- C. This license shall be deemed to contain and is subject to the conditions specified in the following Commission regulations in 10 CFR, Chapter 1: (1) Part 20, Section 30.34 of Part 30, Section 40.41 of Part 40, Section 50.54 and 50.59 of Part 50, and Section 70.32 of Part 70, (2) is subject to all applicable provisions of the Act and to the rules, regulations, and orders of the Commission now or hereafter in effect, and (3) is subject to the additional conditions specified or incorporated below:

The Technical Specifications contained in Appendix A, as revised through Amendment No. 168 are hereby incorporated in the license. The NMC shall operate the facility in accordance with the Technical Specifications.

## LIST OF FIGURES

**FIGURE TS 3.1-1**  
**KEWAUNEE UNIT NO. 1 HEATUP LIMITATION CURVES**  
**APPLICABLE FOR PERIODS UP TO 33<sup>(1)</sup> EFFECTIVE FULL-POWER YEARS**

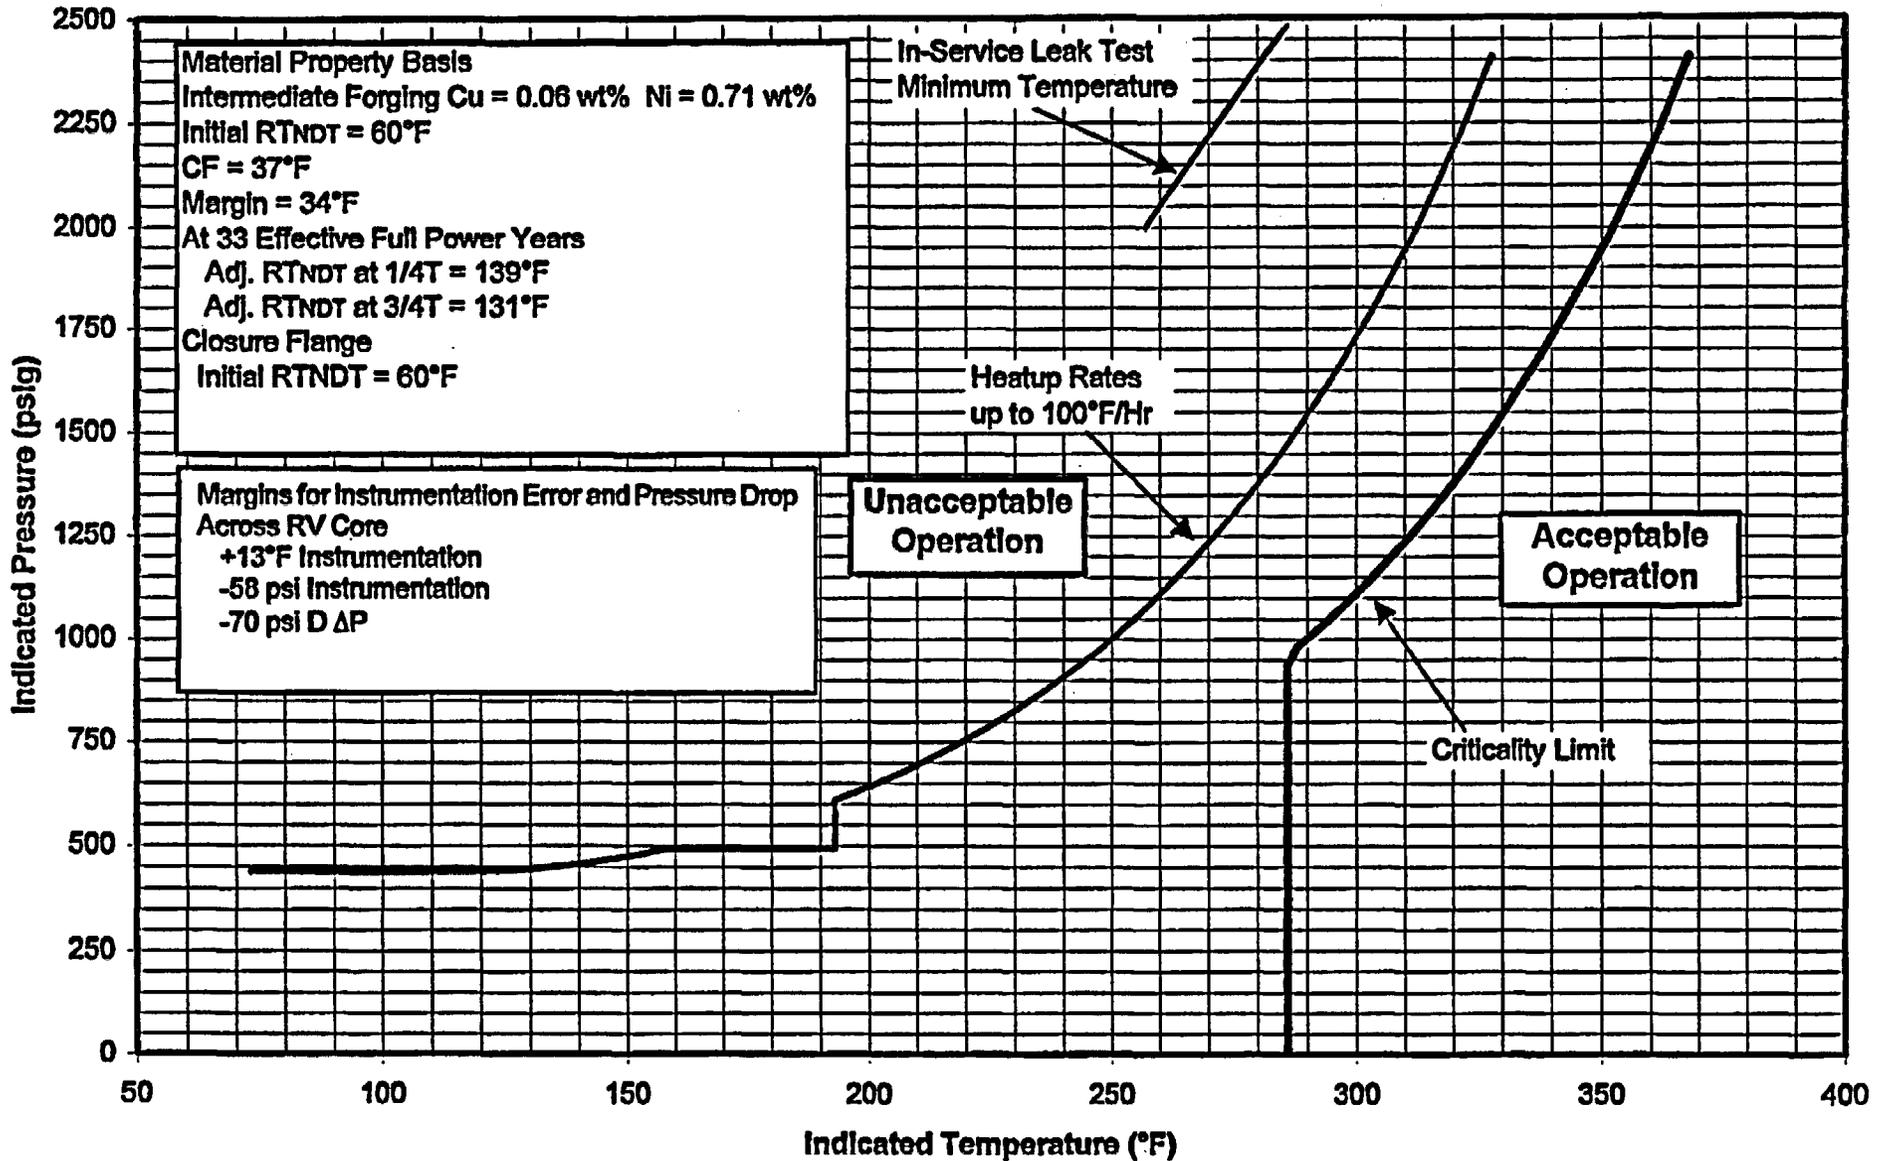
**NOTE:**

<sup>(1)</sup>The curves are limited to 31.1 EFPY due to changes in vessel fluence associated with operation at uprated power.

**FIGURE TS 3.1-2  
KEWAUNEE UNIT NO. 1 COOLDOWN LIMITATION CURVES  
APPLICABLE FOR PERIODS UP TO 33<sup>(1)</sup> EFFECTIVE FULL-POWER YEARS**

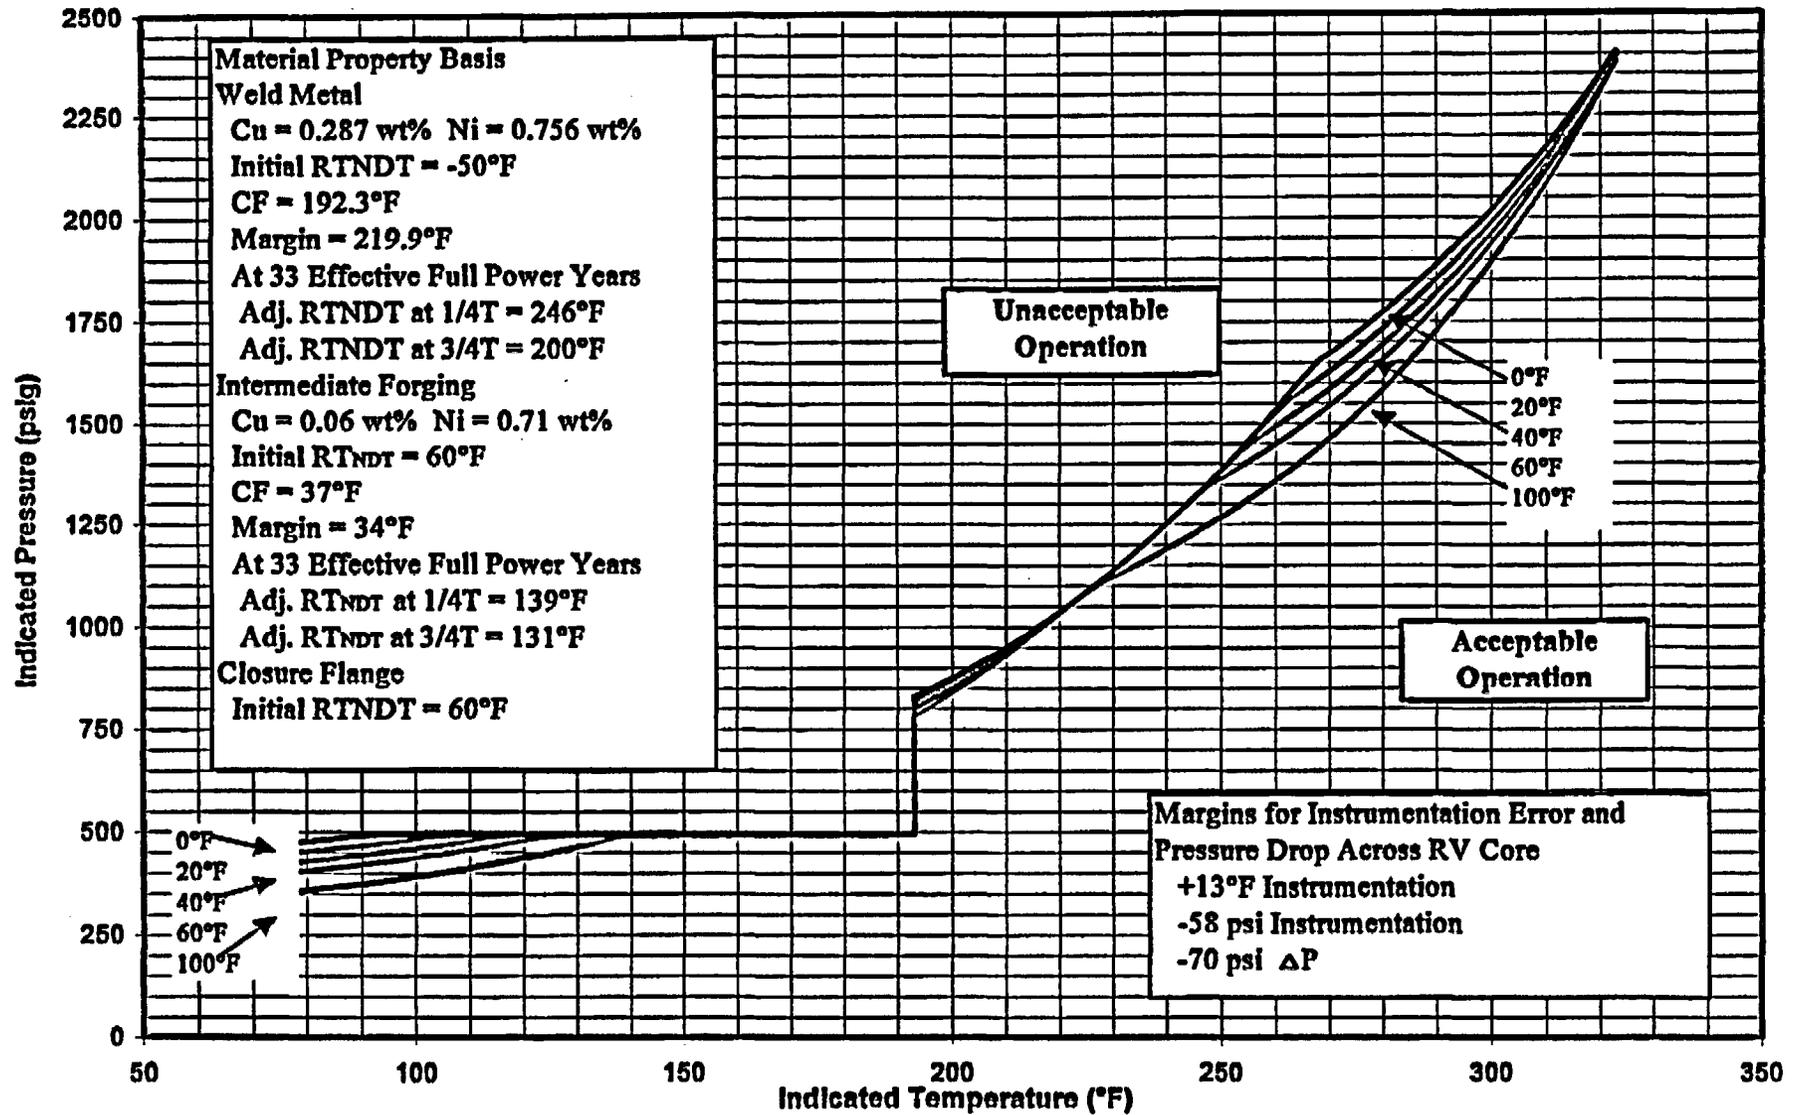
<sup>(1)</sup> The curves are limited to 31.1 EFY due to changes in vessel fluence associated with operation at uprated power.
